Title of Proposed Modification,  
Procedure Change, Test or Experiment: REPLACEMENT OF AUX FEEDWATER PUMP P38A AND P38B CONDUIT SUPPORTS

MODIFICATION/DESIGN PACKAGE 88-099\*D REPLACES THE EXISTING CONDUIT SUPPORT FOR AUX FEEDWATER PUMPS P38A AND P38B. THE CONDUIT SUPPORTS ARE LOCATED IN THE AUX FEEDWATER PUMP ROOM BETWEEN COLUMNS E-F AND 10-12. THE EXISTING SUPPORTS ARE ATTACHED TO THE CONCRETE WALLS AT AN APPROXIMATE ELEVATION OF 15'-1". THE CONDUIT SUPPORTS ARE BEING REPLACED TO PROVIDE ADDITIONAL SPACE NEEDED FOR THE INSTALLATION, OPERATION, AND MAINTENANCE OF NEW CONTROL VALVES ON THE AUX FEEDWATER RECIRC LINE

FOR MODIFICATION # MR 88-099, MWR # 91-2810  
(DESIGN PACKAGE 88-099)

MICROFORM NO			TITLE			
SK-ELEC-012/MR 88-099KD SHEET 1 OF 16			AUX FEEDWATER PUMP CO SUPPORTS P38A AND P38B			
DRAWN <i>S+L</i> DATE	APPRVD. <i>[Signature]</i> DATE <i>7/2/91</i>	<b>A</b>				
CHECKED <i>[Signature]</i> DATE <i>7/2/91</i>	APPRVD.		SCALE			
DRAFTG.	APPRVD.		RELEASE DATE

MICROFORM NO.		SHEET 6 OF 16	
SK-ELEC-OIZ/MR-88-011KD		DATE: 2/1/91	
DRAWN BY: [Signature]		SCALE: 1/4" = 1'-0"	
PROJECT: WISCONSIN ELECTRIC		RELEASE DATE: [Blank]	
TITLE: MIX FEEDWATER PUMP CONDUIT		SHEET 6 OF 16

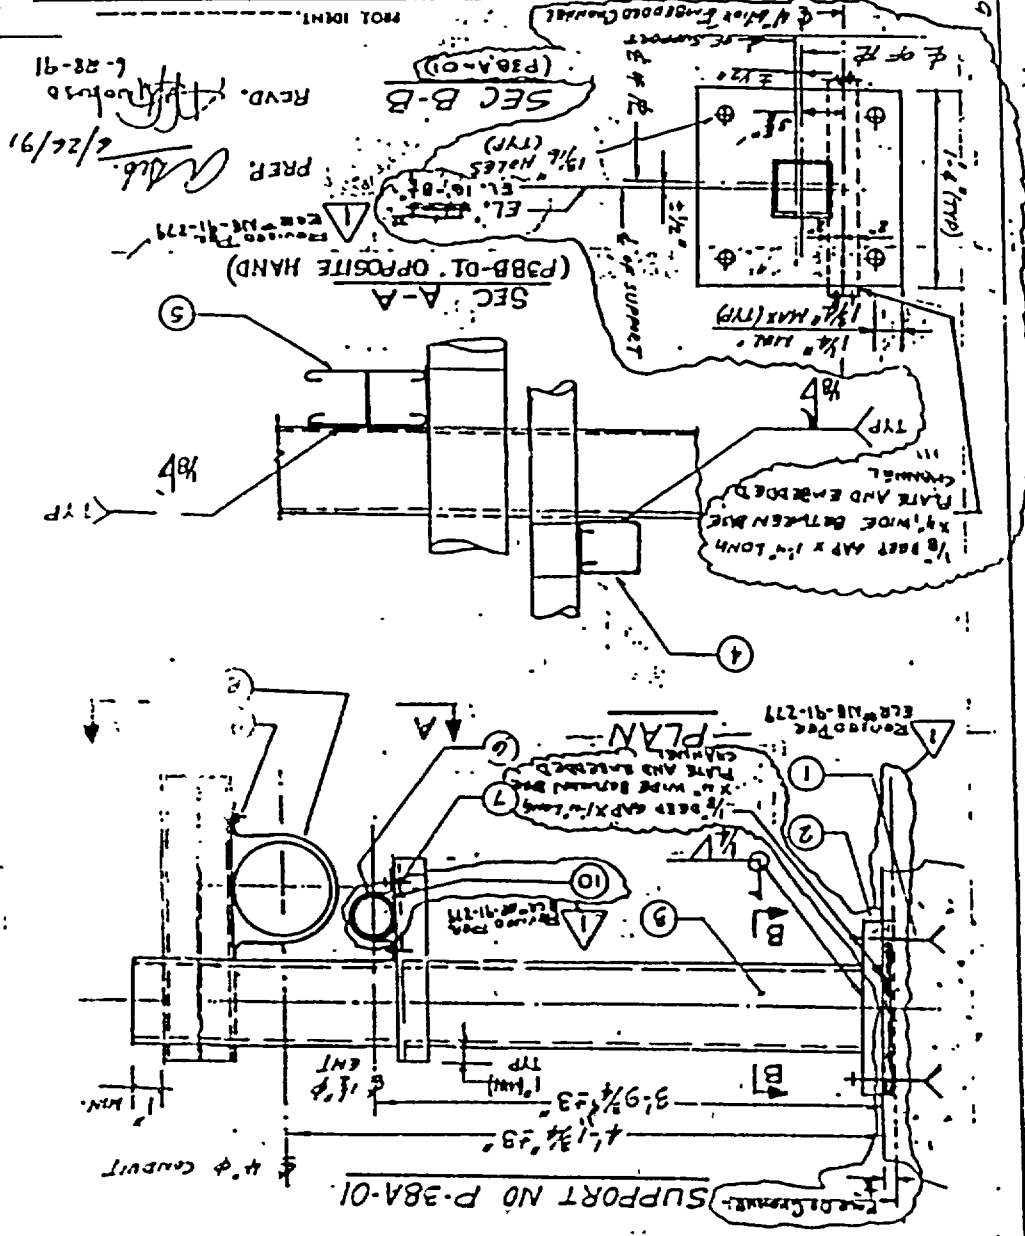
REV. NO.	DATE	DESCRIPTION
1	2/16/91	REVISED FOR ECR #18-91-279

MICROFORM NO		 Wisconsin Electric		PROJ. IDENT.	
SK-ELEC-012/MR 88-099MD				TITLE	
SHEET 8 OF 16				AUX. FEEDWATER PUMP CONDUIT SUPPORTS P38A AND P38B	
DRAWN <u>S&amp;L</u>	DATE	APPRVD. <u>[Signature]</u>	DATE		
CHECKED <u>[Signature]</u>	7/2/91	APPRVD.			
DATE		APPRVD.		SCALE	RELEASE DATE

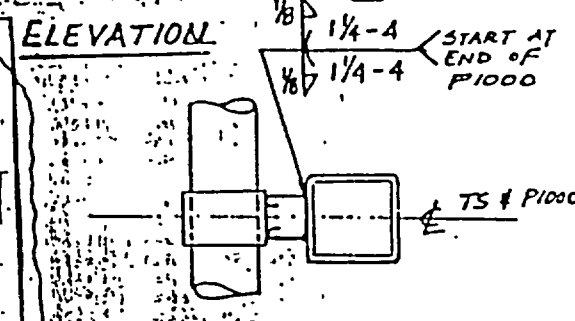
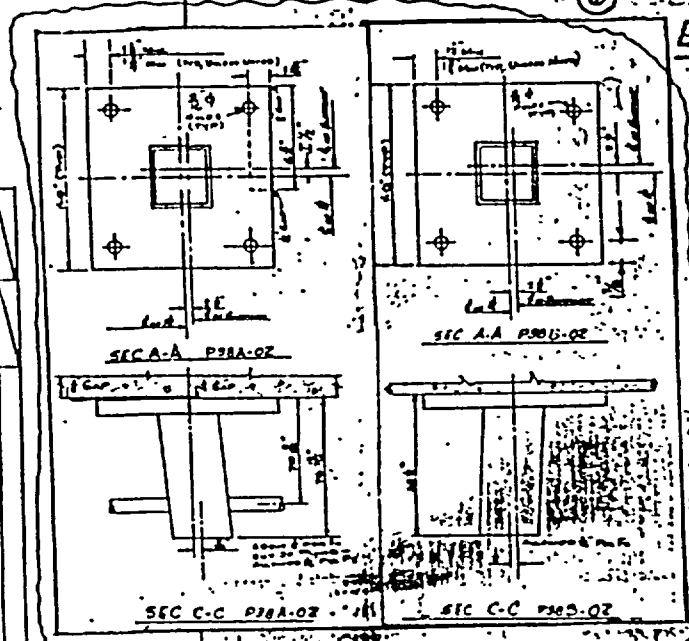
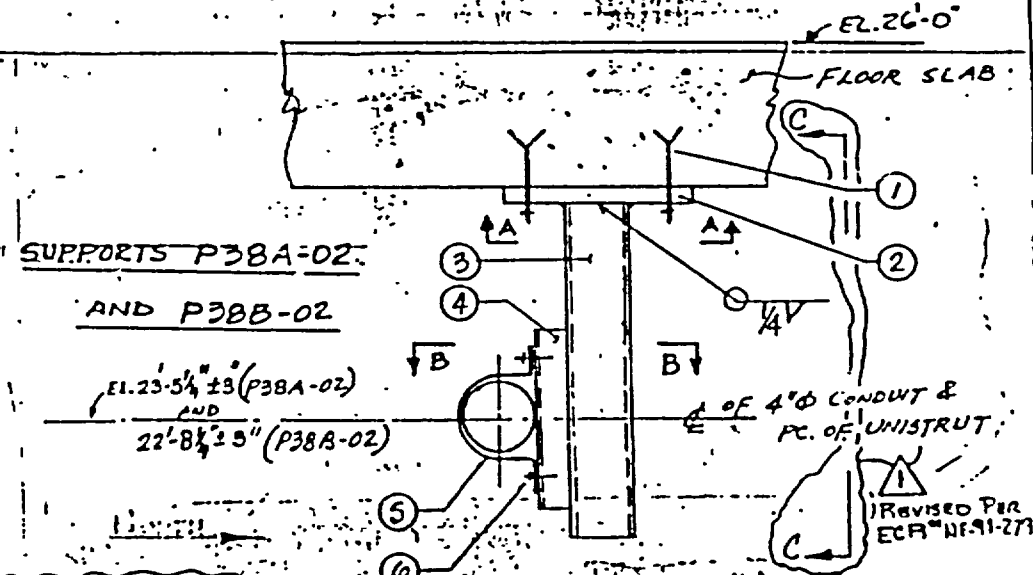
BY	DATE	DESCRIPTION
W.E.	10-01-91	REVISION PER ECR # 91-279

SEC B-B  
 REVISED PER ECR # 91-279  
 PREP. *A. Sub.*  
 6/26/91  
 REVD. *A. Sub.*  
 PROJ. IDENT.

MICROFORM NO.		SK-ELEC-012/MR 88-099KD		SHEET 11 OF 16	
TITLE		AUX FEED WATER PUMP CONDUIT		SUPPORTS P38A AND P38B	
PROJECT IDENT.		WISCONSIN ELECTRIC		DATE 2/2/91	
PROJECT IDENT.		WISCONSIN ELECTRIC		DATE 2/2/91

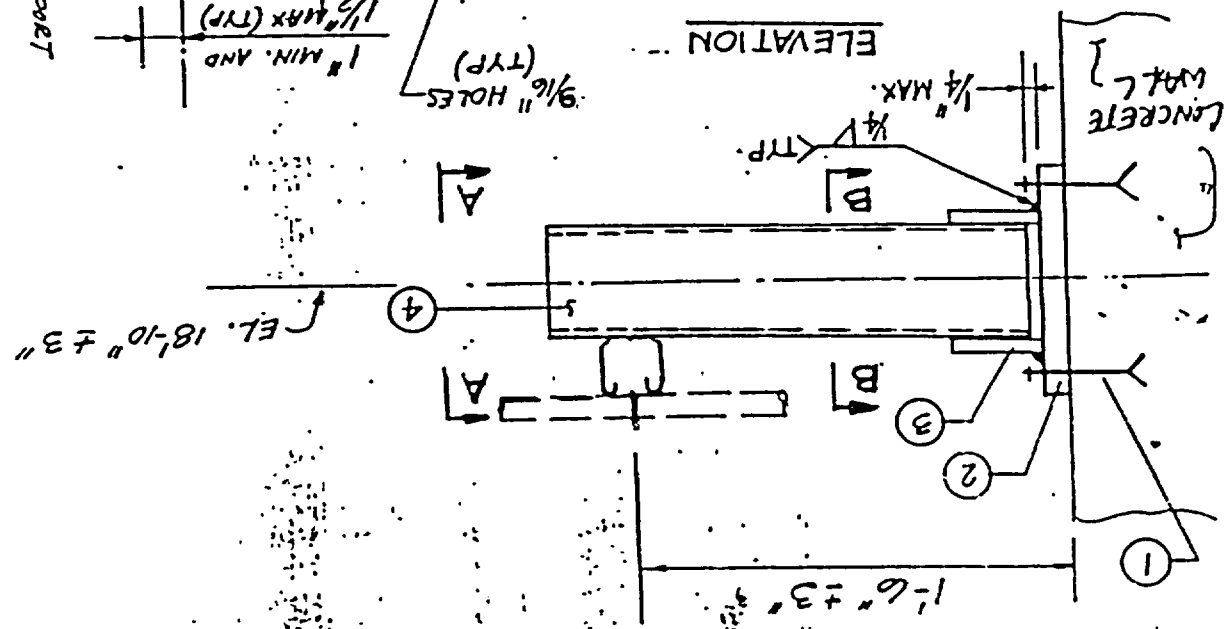
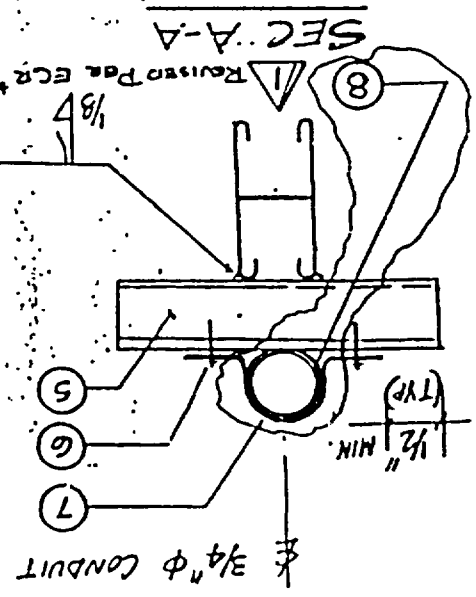
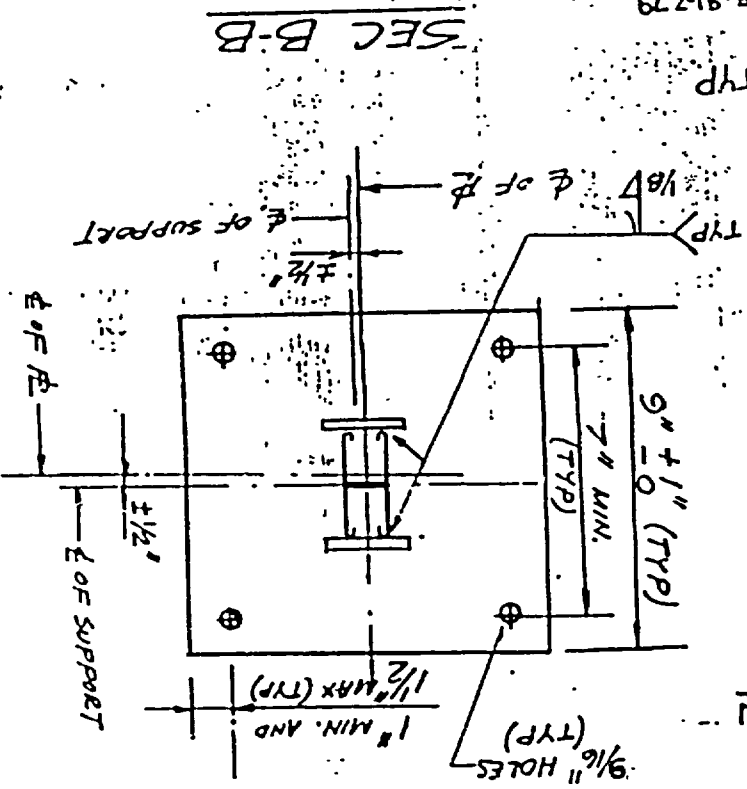
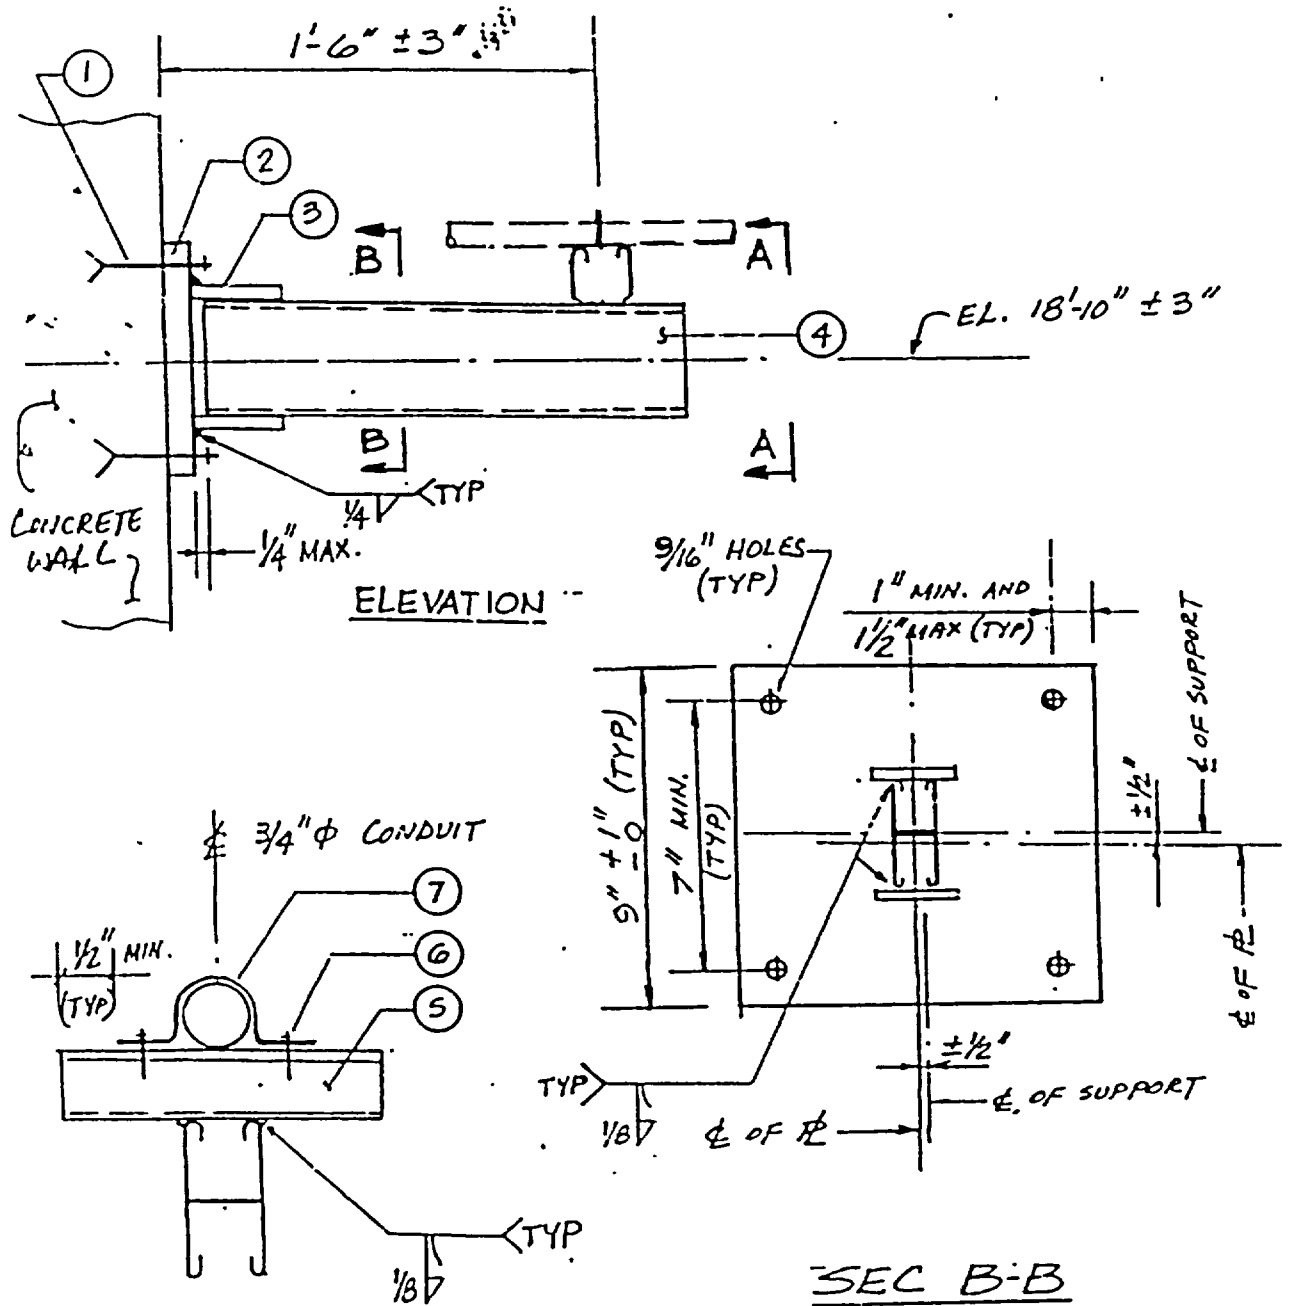
1	01-06-92	REVISION FOR ECR # NE-91-279

PLAN EL. 8'-0"  
P3BA PUMP ABODE

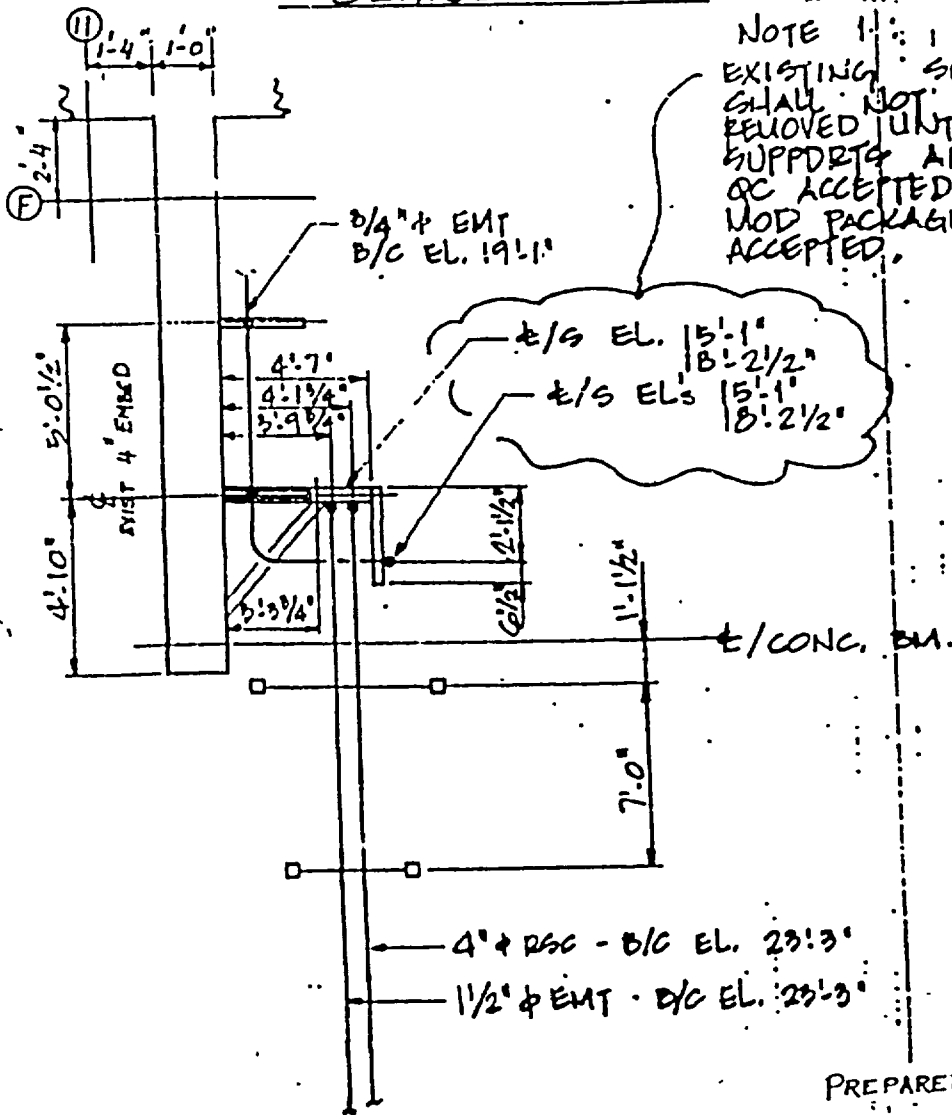
NOTE: EXISTING SUPPORTS SHALL NOT BE REMOVED UNTIL NEW SUPPORTS ARE INSTALLED OR ACCEPTED AND THE MOD PACKAGE IS ACCEPTED.
